SUBJECT: Waterford 3 SES  
Docket No. 50-382  
Additional Information on Basemat Cracks

RESPONSE TO DR. J MA'S QUESTION  
OF 11/16/84

RESPONSE TO DR. J MA's QUESTION  
OF 11/16/84

## RESPONSE TO DR. J MA's QUESTION OF 11/26/84

SHEET 3 OF 7  
 DEPT. NO. \_\_\_\_\_

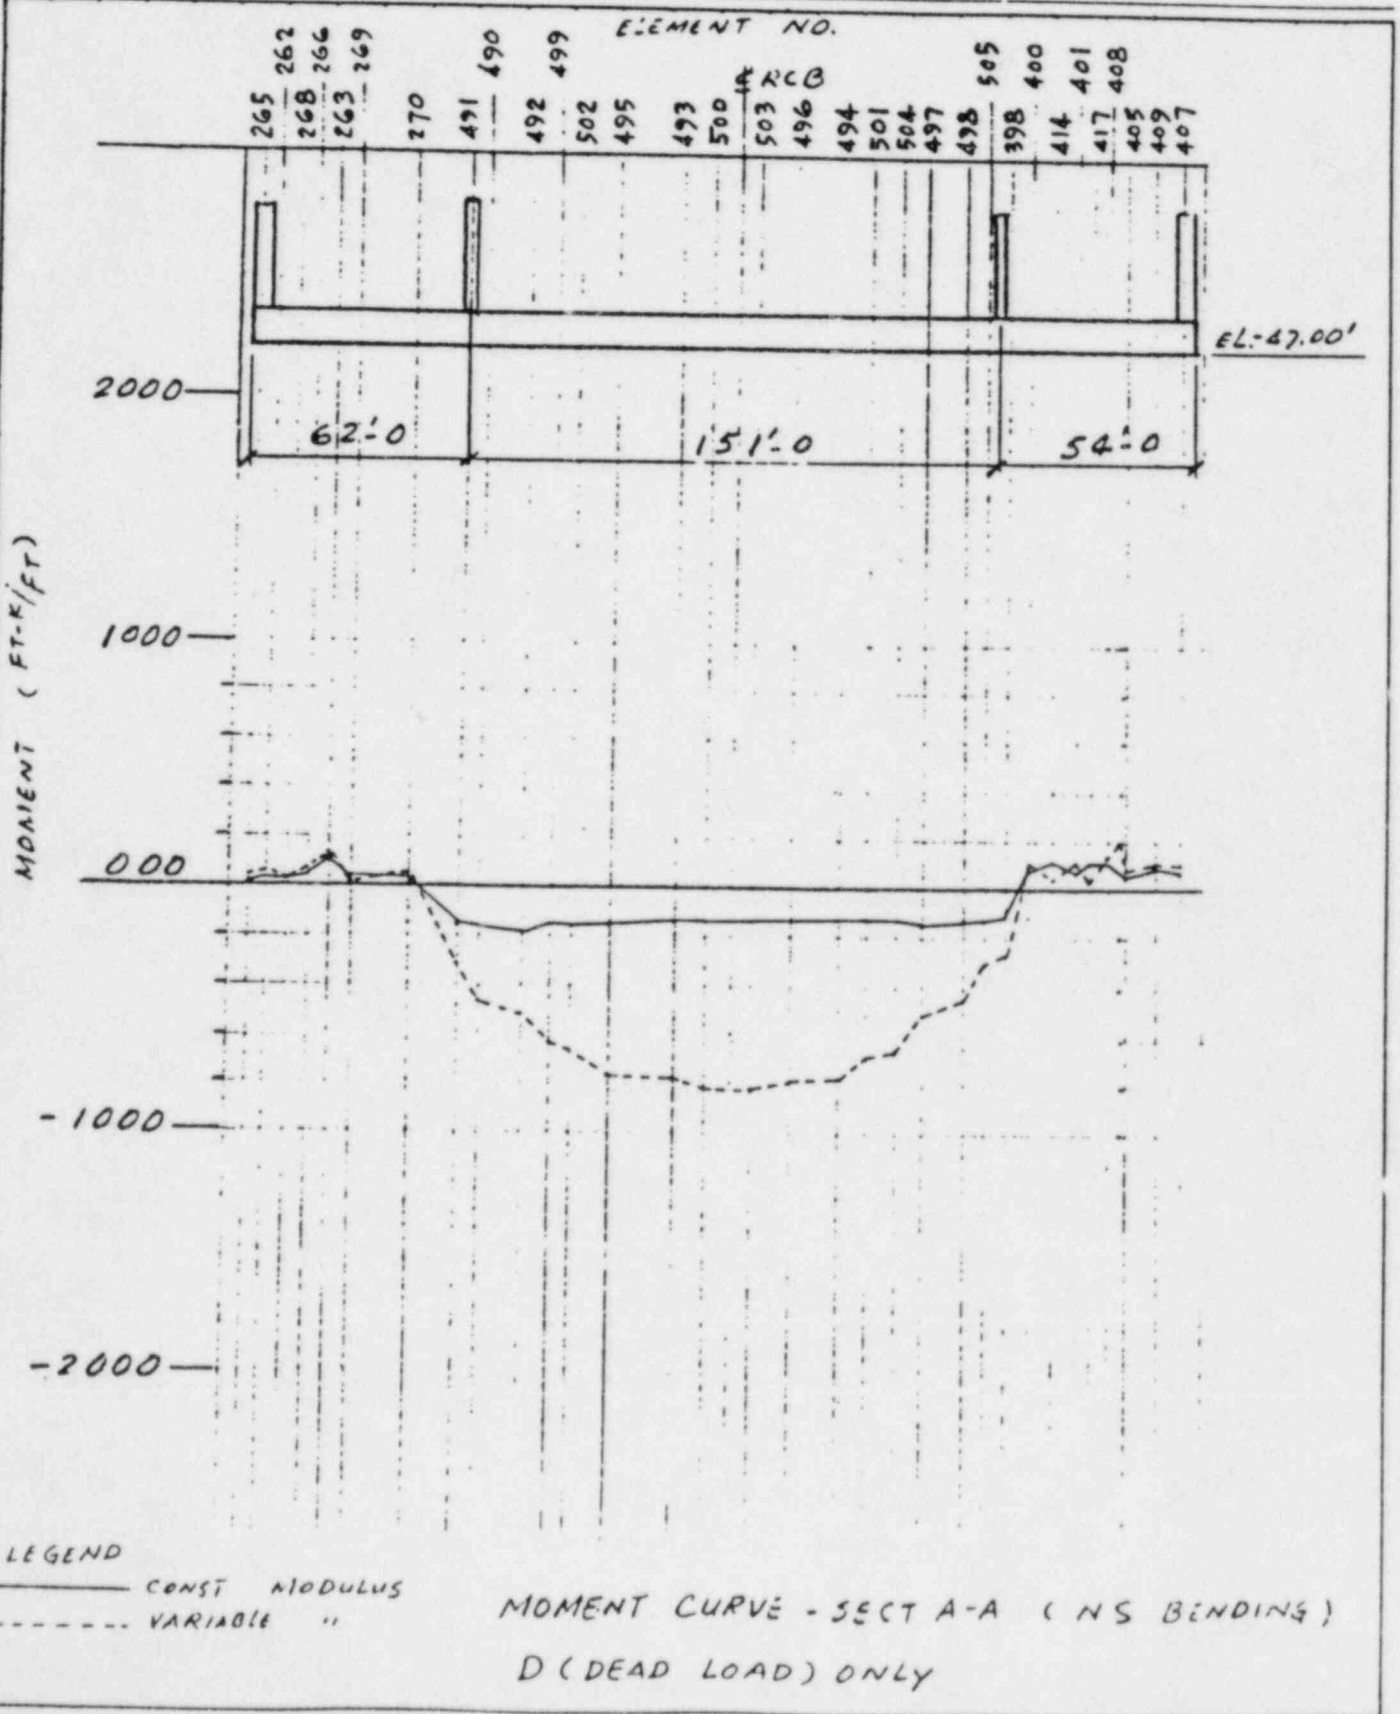
Q2. Provide N-S bending moment diagram along Section A-A of the basemat for the following load conditions:

- a. Constant soil springs with side soils
- b. Constant soil springs without side soils
- c. Variable soil springs with side soils
- d. Variable soil springs without side soils

Ans. a&c See Sh 2 of 7  
b&d See Sh 3 of 7

SHEET 2 OF 7

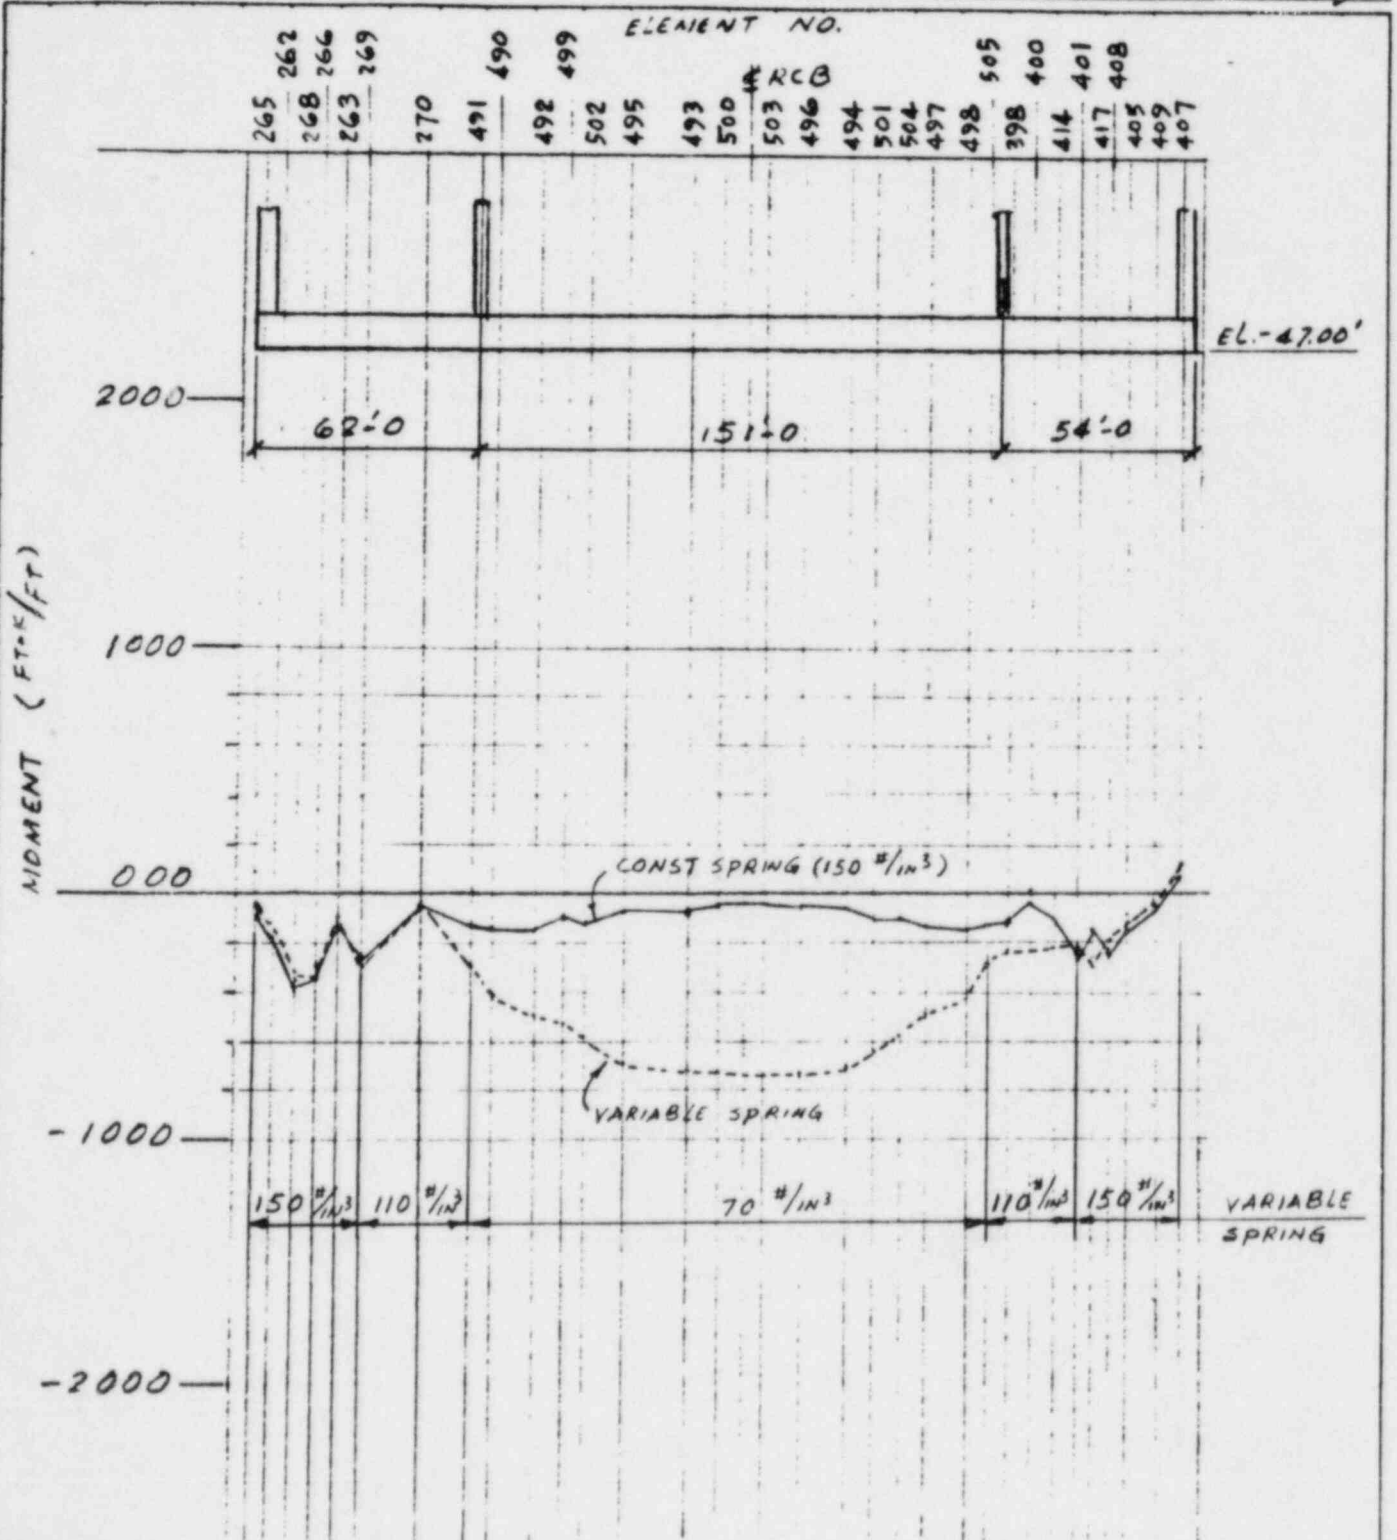
Q1. Provide soil spring distribution related to the basemat N-S bending moment.

Ans. The soil spring distribution is shown in attached Revision -1 of Sh 2/7 and Sh 3/7 of which were submitted previously on 11/19/84.

TOP BARS (AREA I, II & III) AT SECT A-A

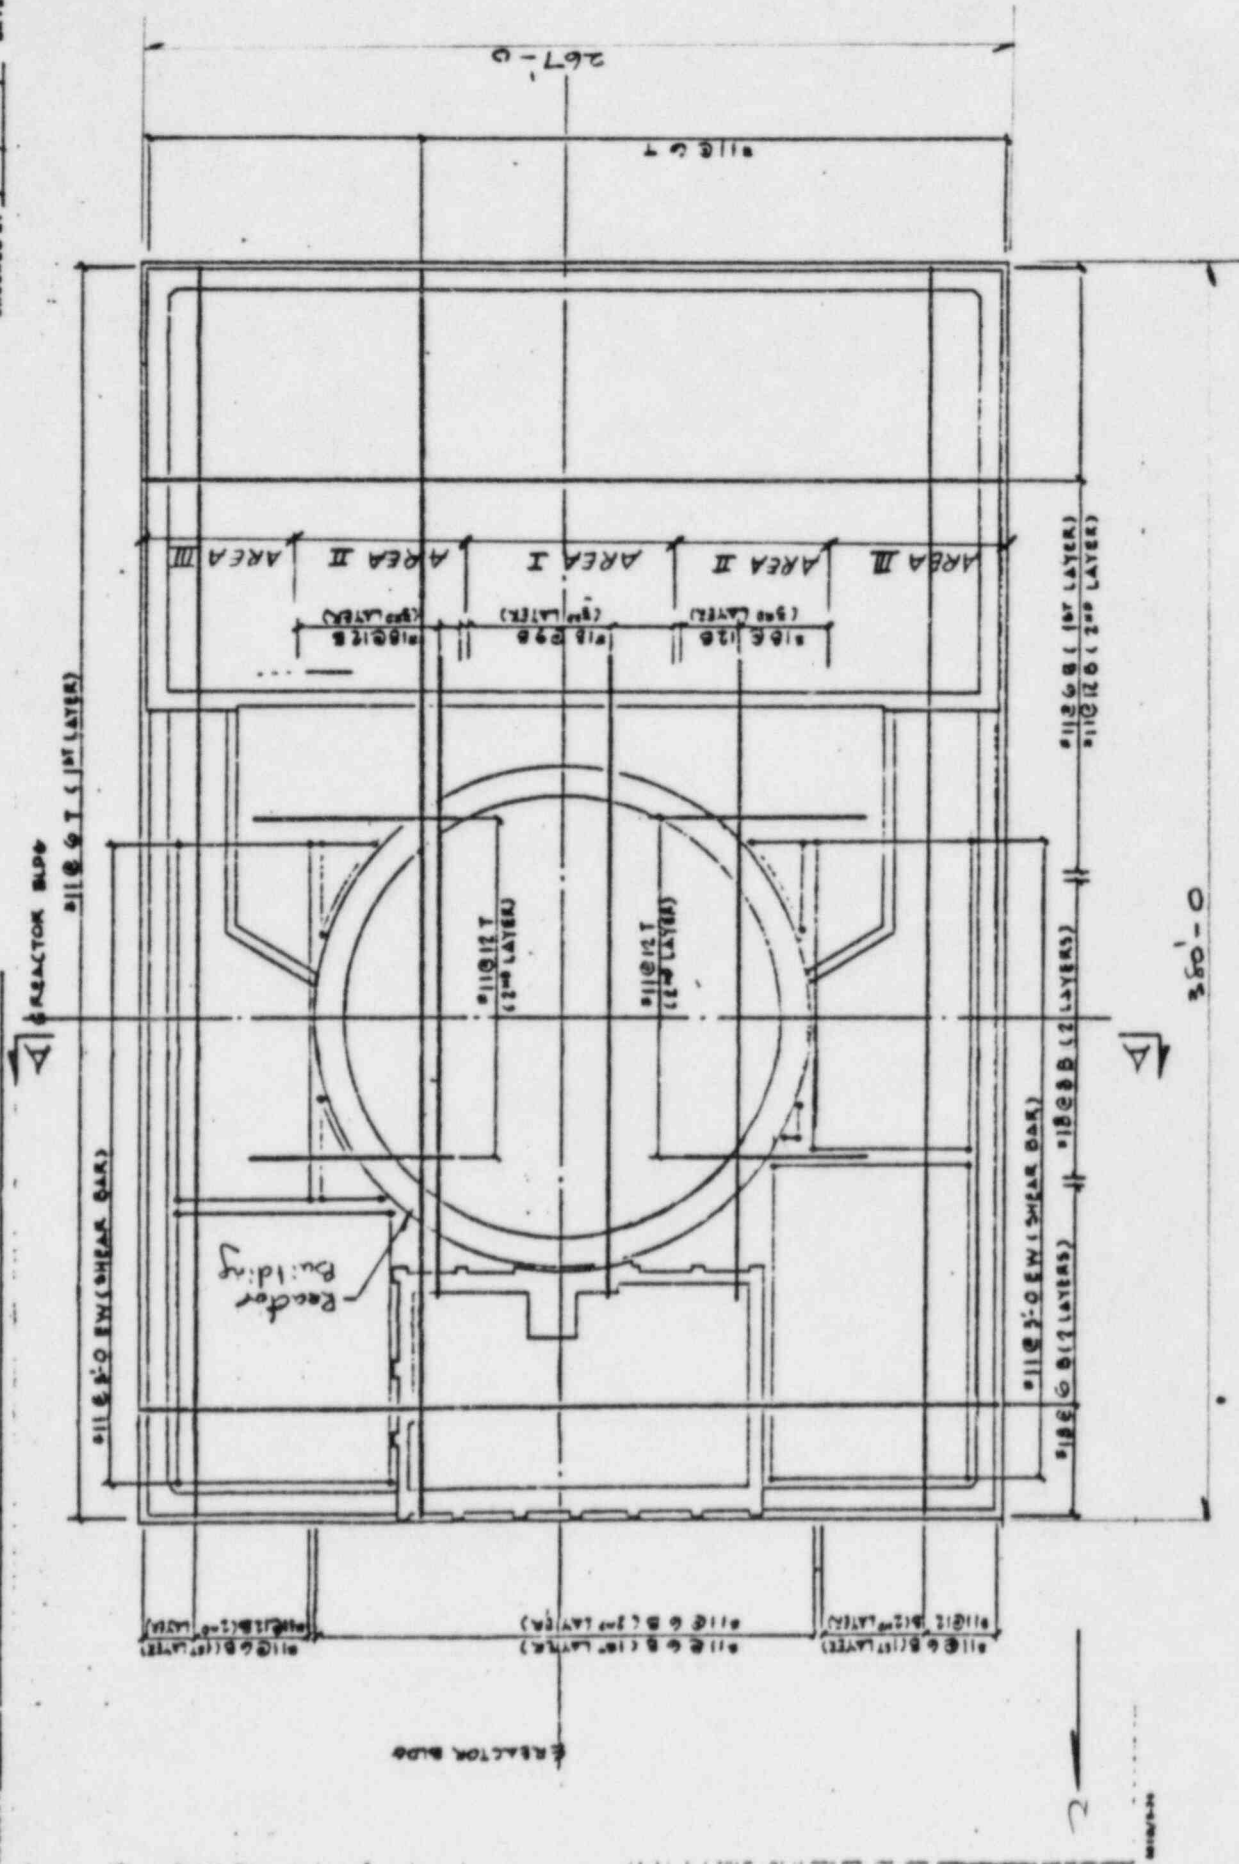
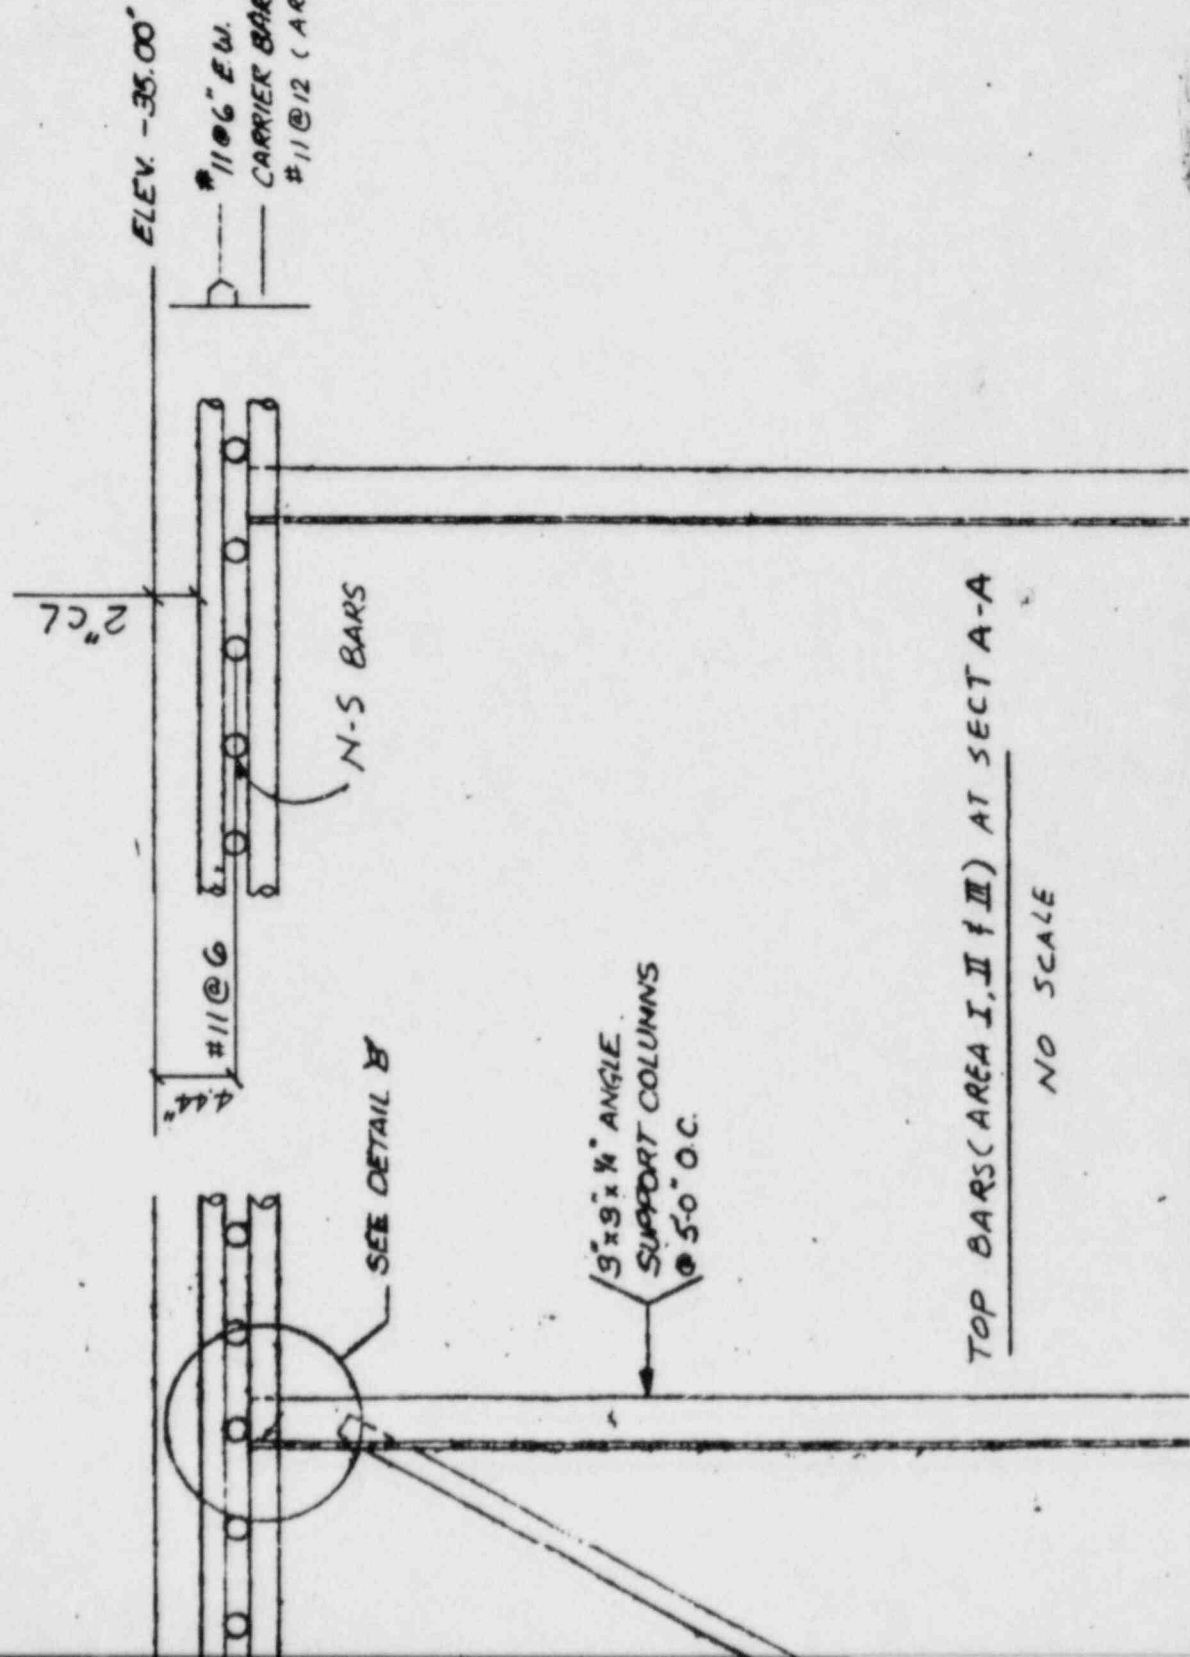
Q3. Revise Sh 3/6 to include #11 @ 12 re-bars.

Ans. See revised Sh 3/6 attached.
